15037-R08-A

11 July 2019

Old Granada Studios, Manchester

Stage 4 acoustic design report – zone 6

Title
Zone 6 - GA Plan - Level 07

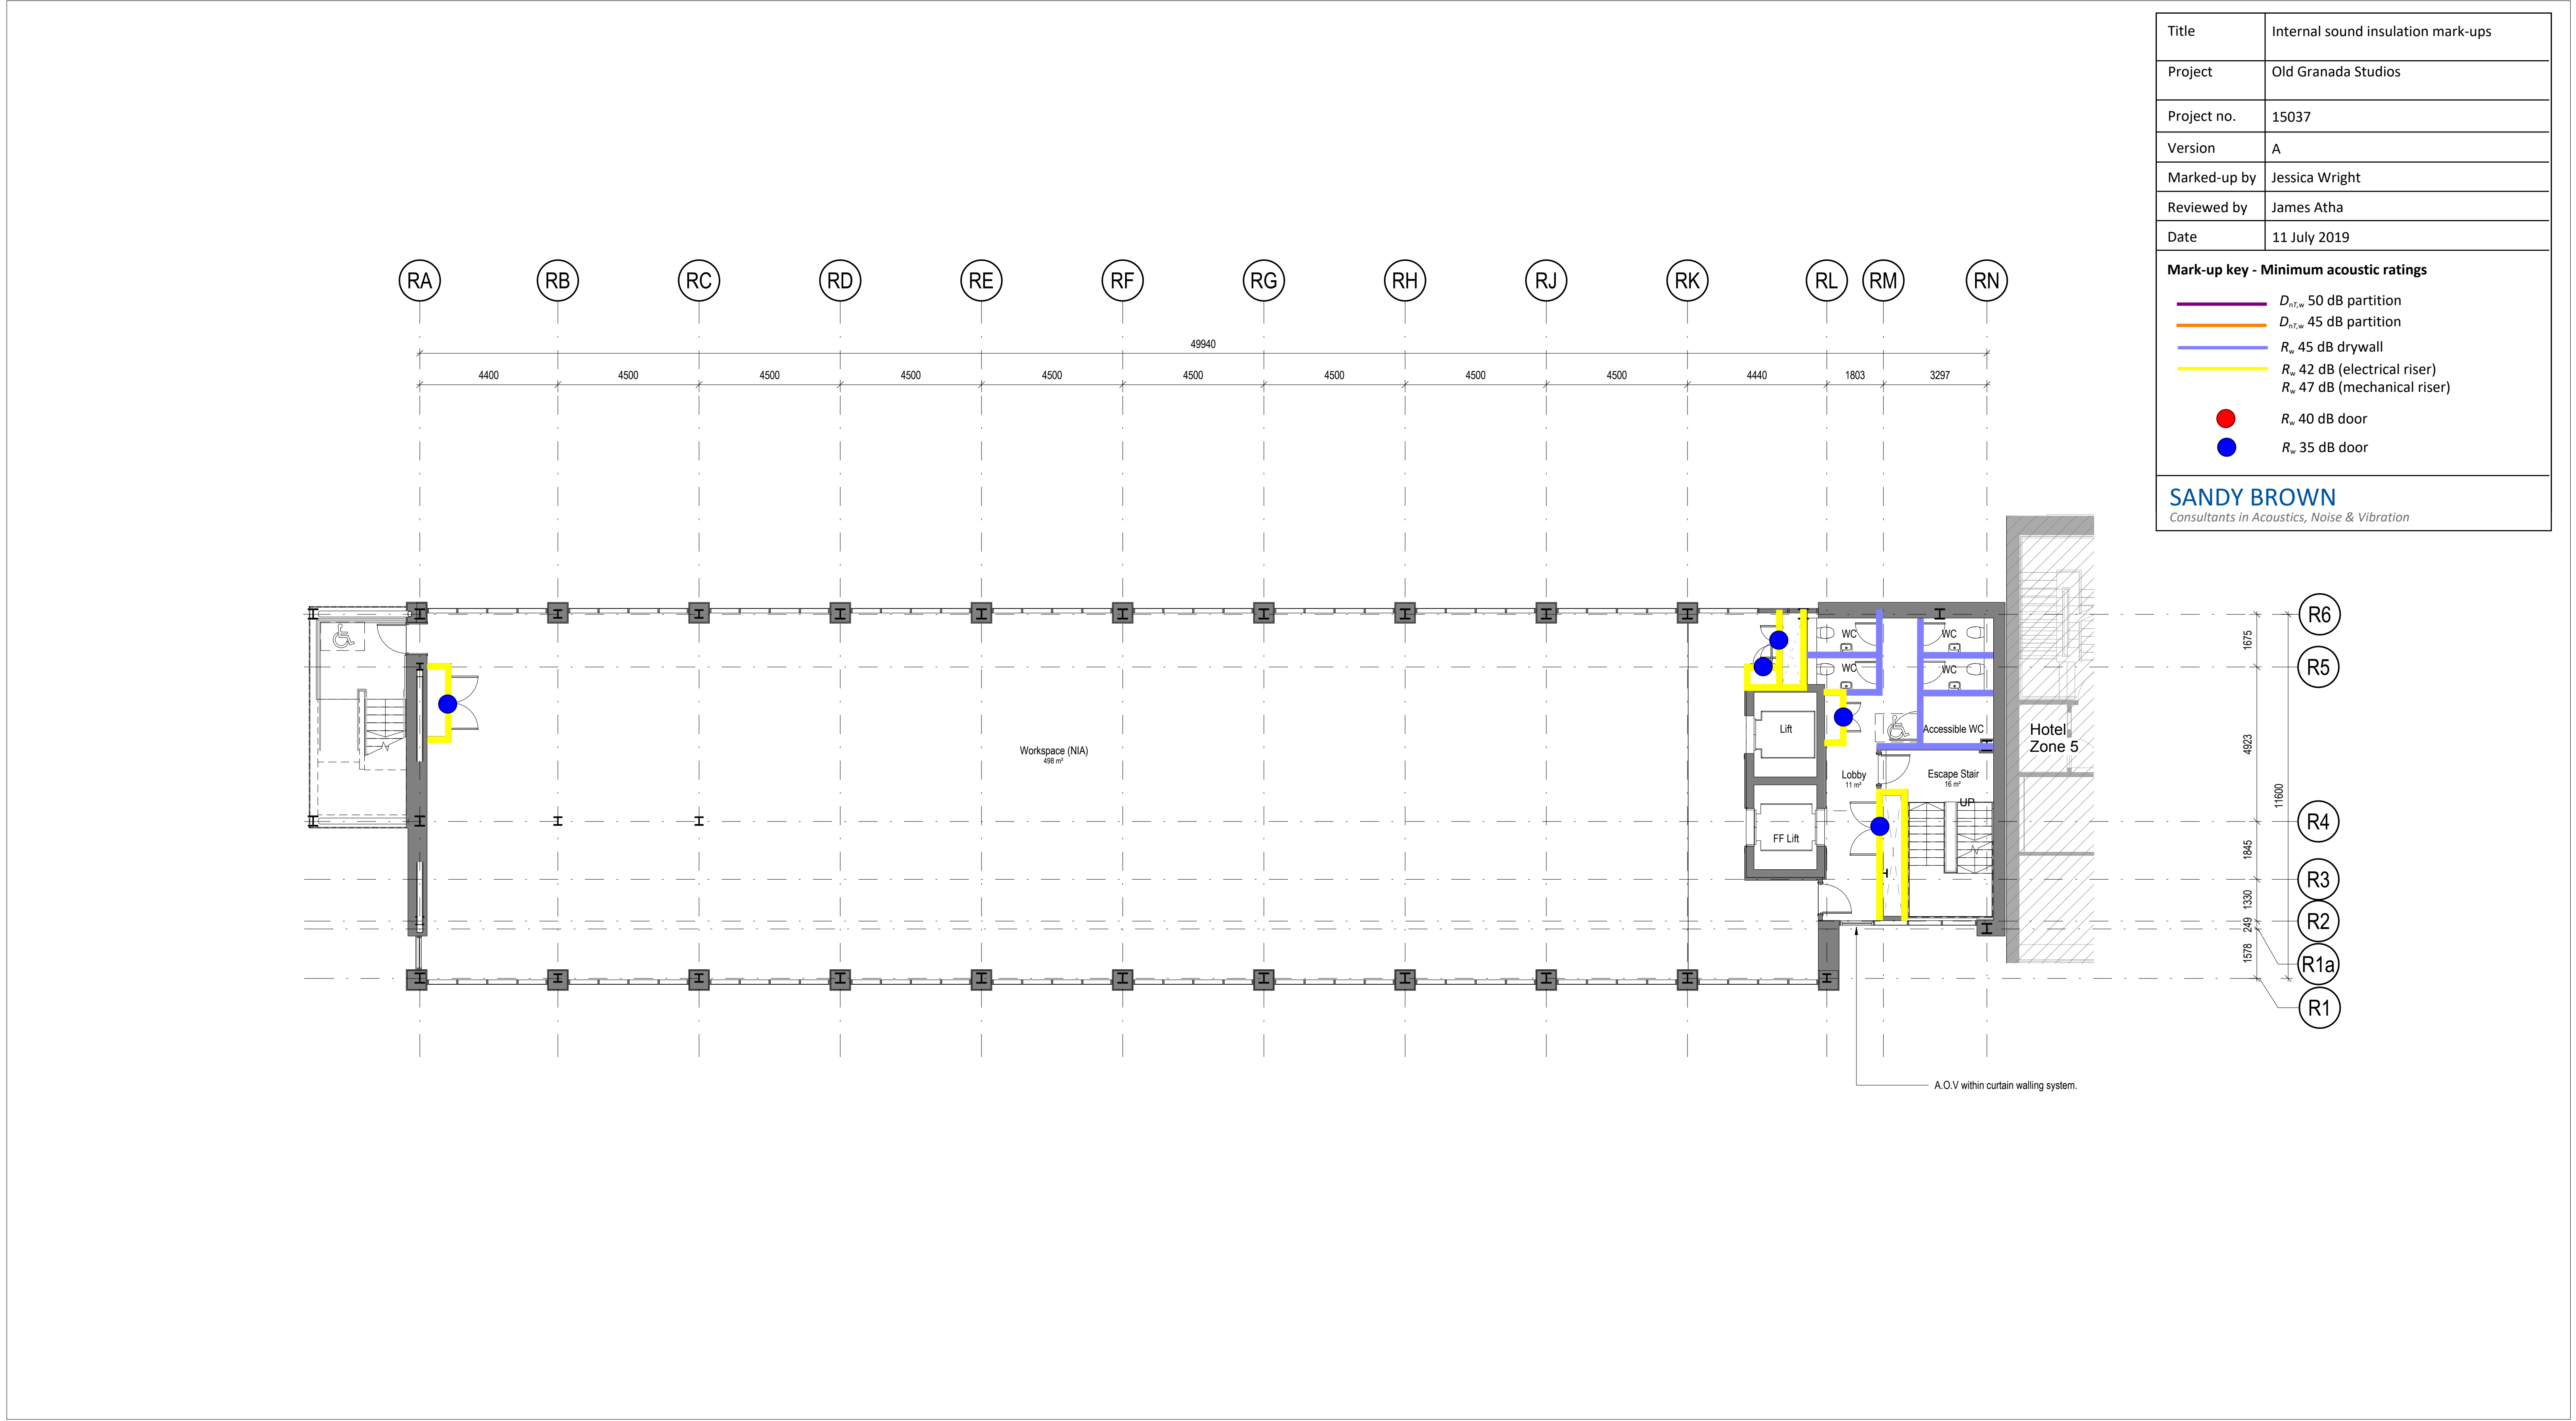
- Mark-up key - Minimum acoustic ratings**
- $D_{nT,w}$ 50 dB partition
 - $D_{nT,w}$ 45 dB partition
 - R_w 45 dB drywall
 - R_w 42 dB (electrical riser)
 - R_w 47 dB (mechanical riser)
 - R_w 40 dB door
 - R_w 35 dB door

Zone 6 - GA Plan - Level 08

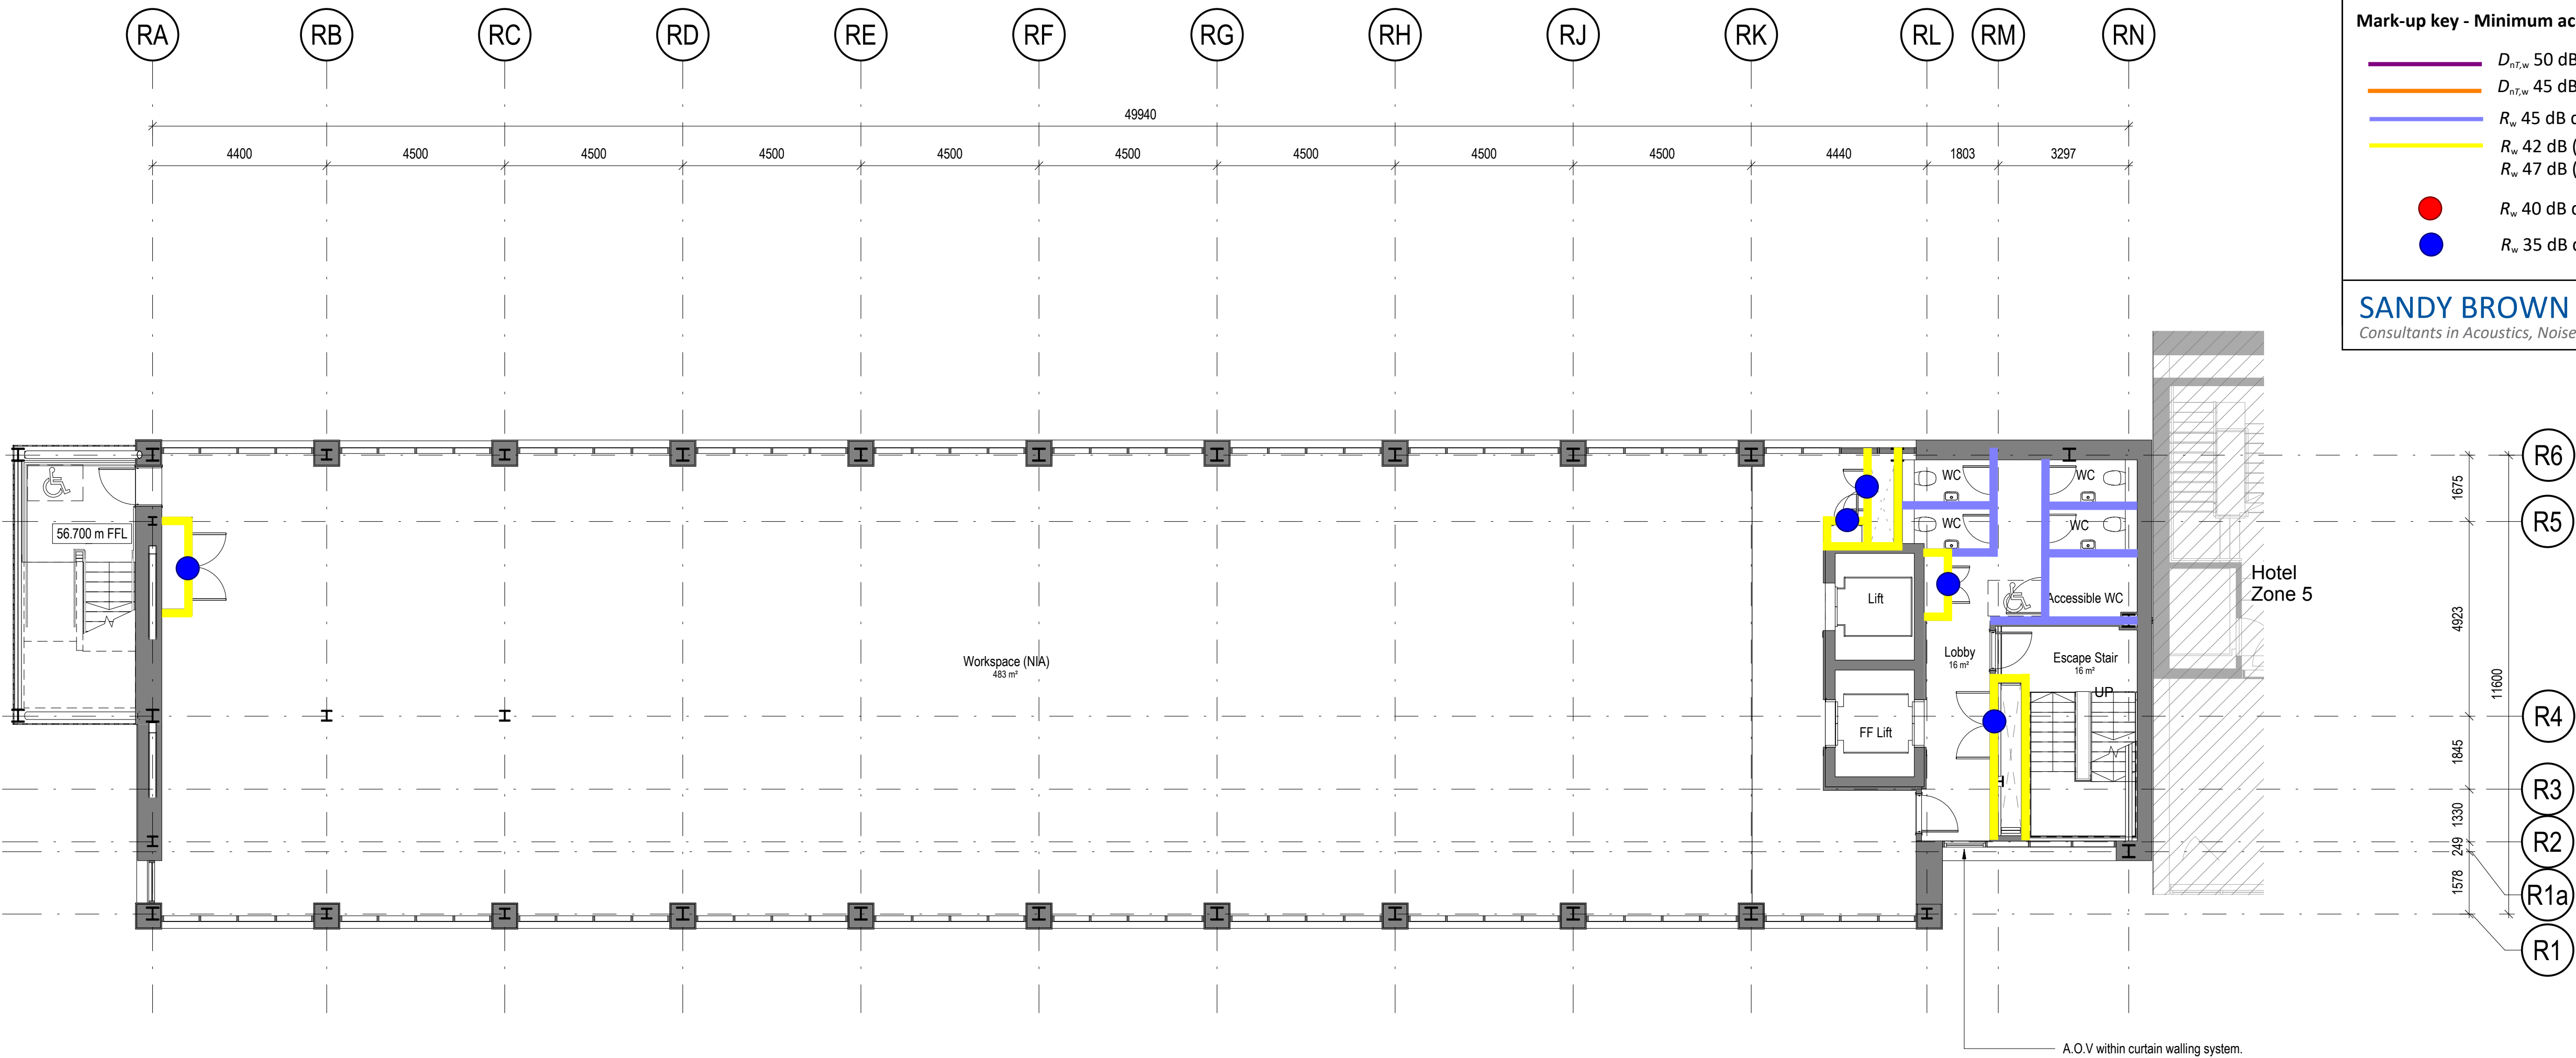
- $D_{nT,w}$ 50 dB partition
- $D_{nT,w}$ 45 dB partition
- R_w 45 dB drywall
- R_w 42 dB (electrical riser)
 R_w 47 dB (mechanical riser)
- R_w 40 dB door
- R_w 35 dB door

Zone 6 - GA Plan - Level 09

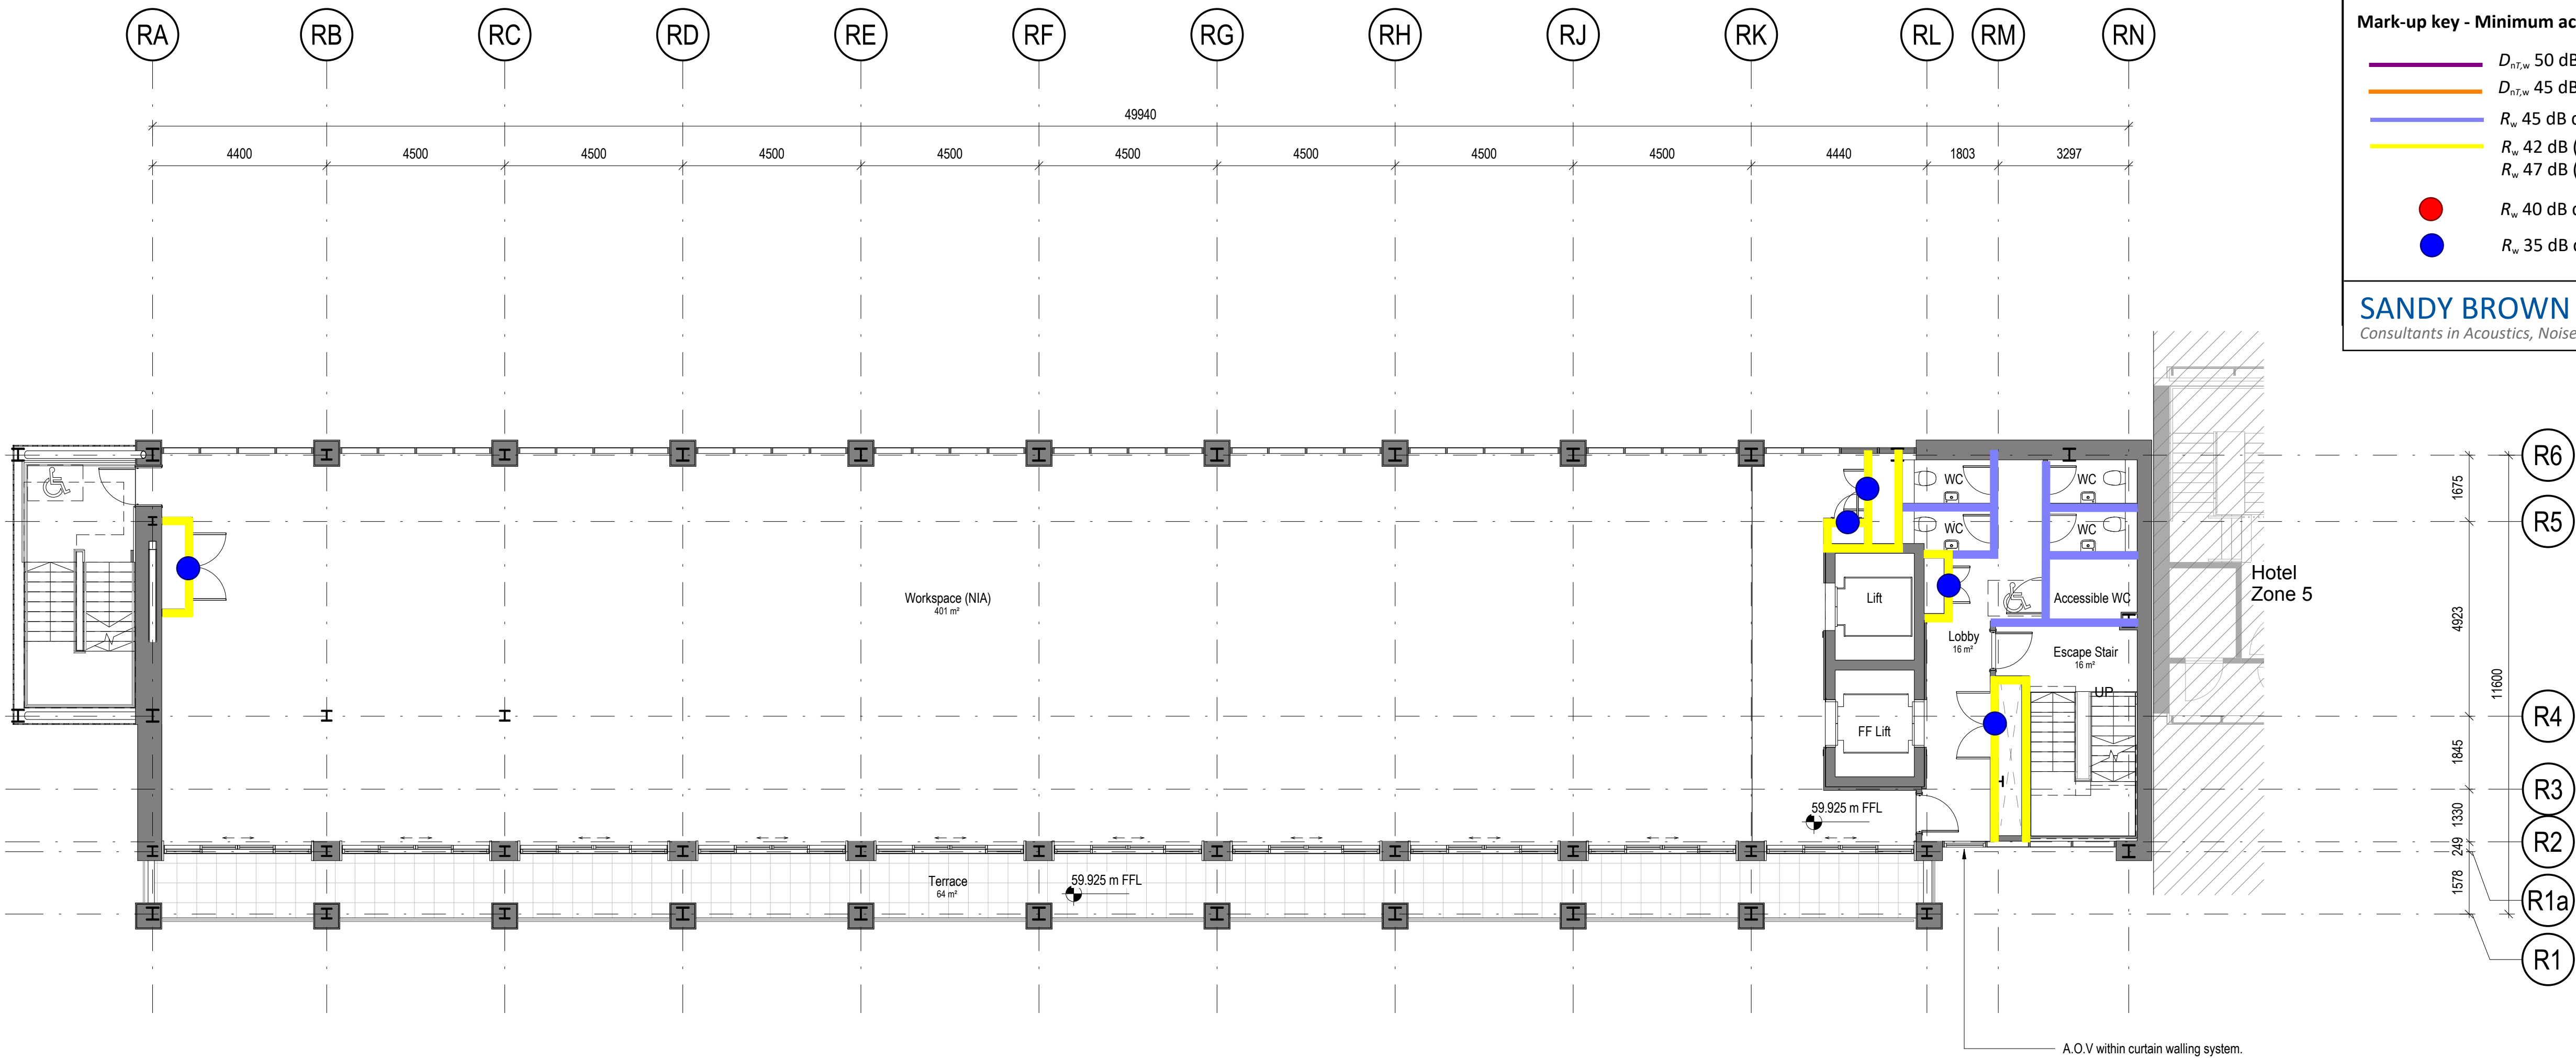
- Mark-up key - Minimum acoustic ratings**
- $D_{nT,w}$ 50 dB partition
 - $D_{nT,w}$ 45 dB partition
 - R_w 45 dB drywall
 - R_w 42 dB (electrical riser)
 R_w 47 dB (mechanical riser)
 - R_w 40 dB door
 - R_w 35 dB door

Title
Zone 6 - GA Plan - Level 10

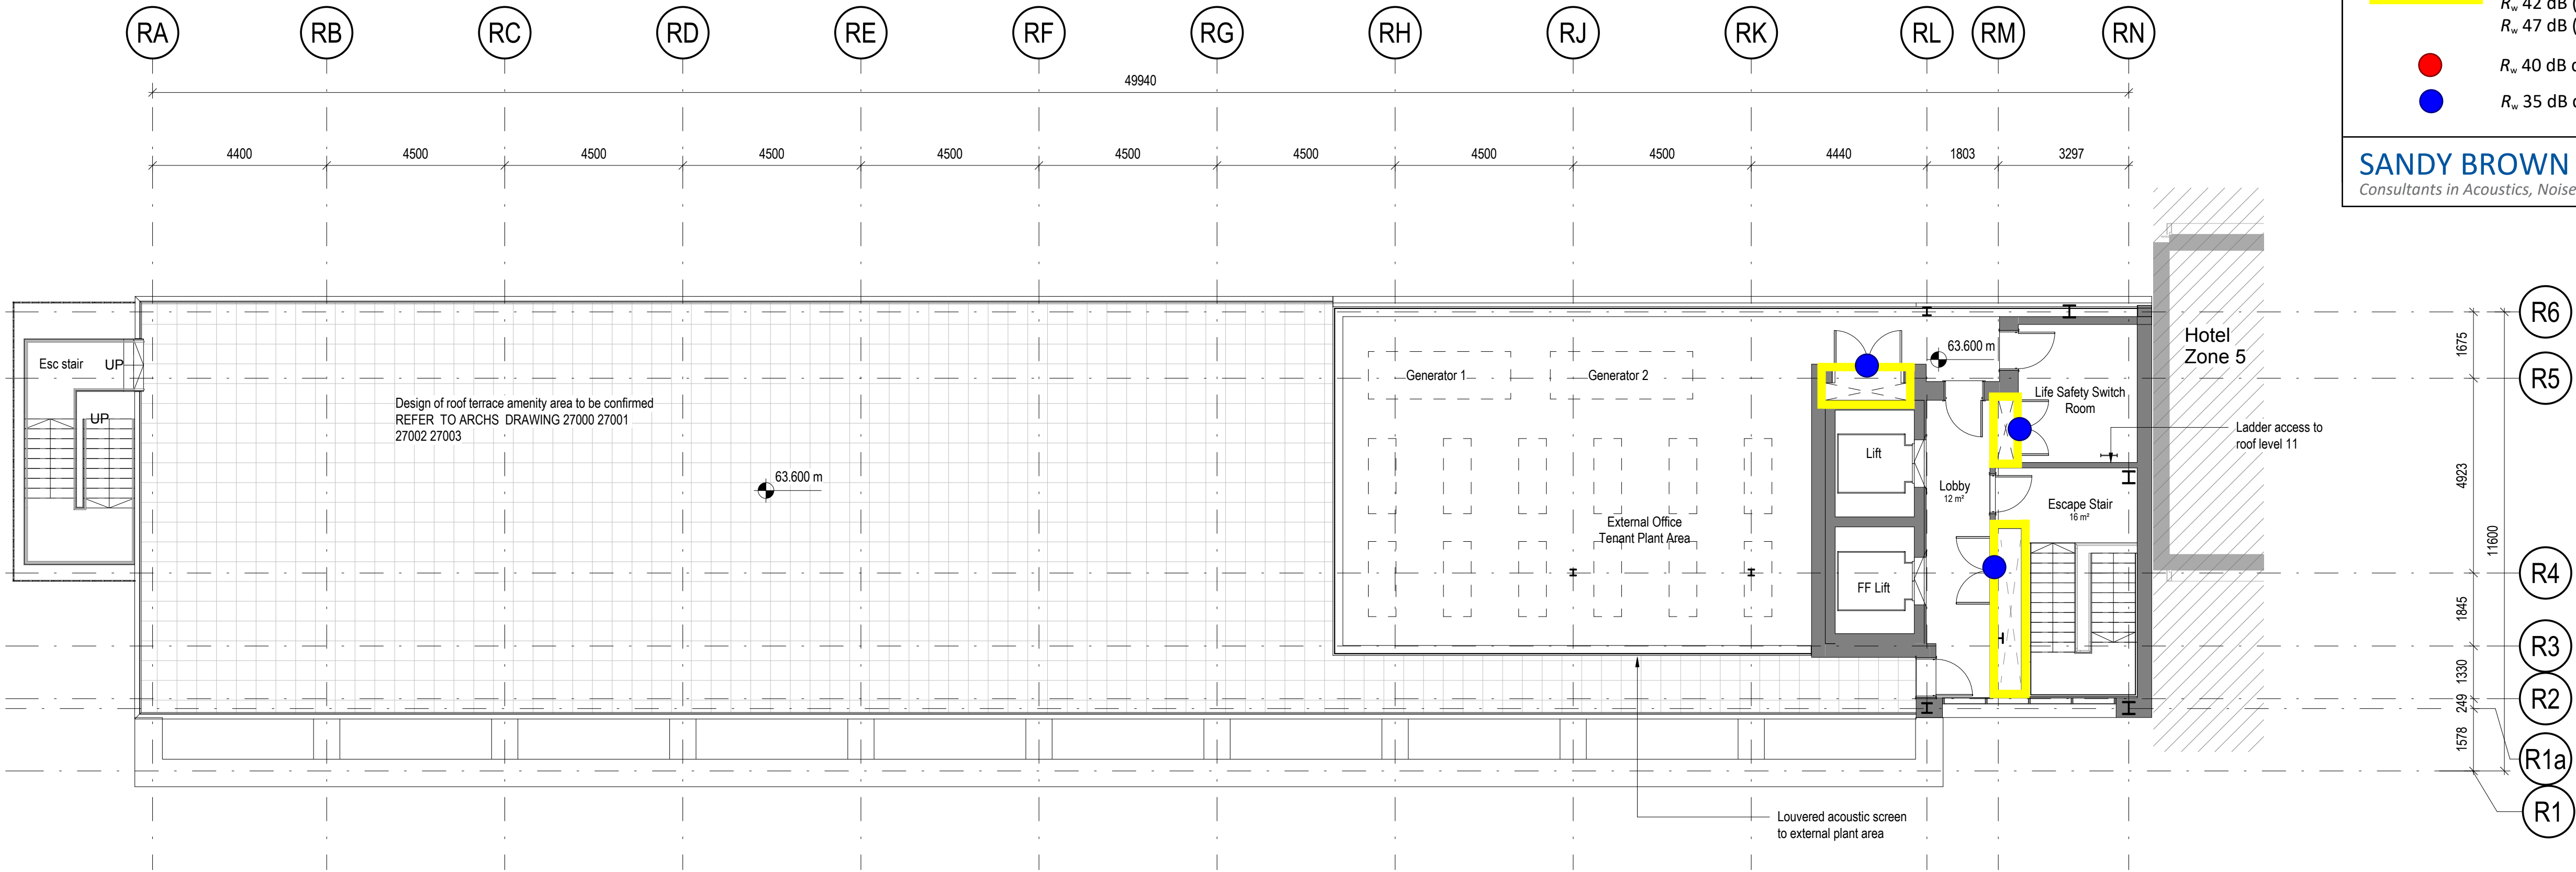
- Mark-up key - Minimum acoustic ratings**
- $D_{nT,w}$ 50 dB partition
 - $D_{nT,w}$ 45 dB partition
 - R_w 45 dB drywall
 - R_w 42 dB (electrical riser)
 R_w 47 dB (mechanical riser)
 - R_w 40 dB door
 - R_w 35 dB door
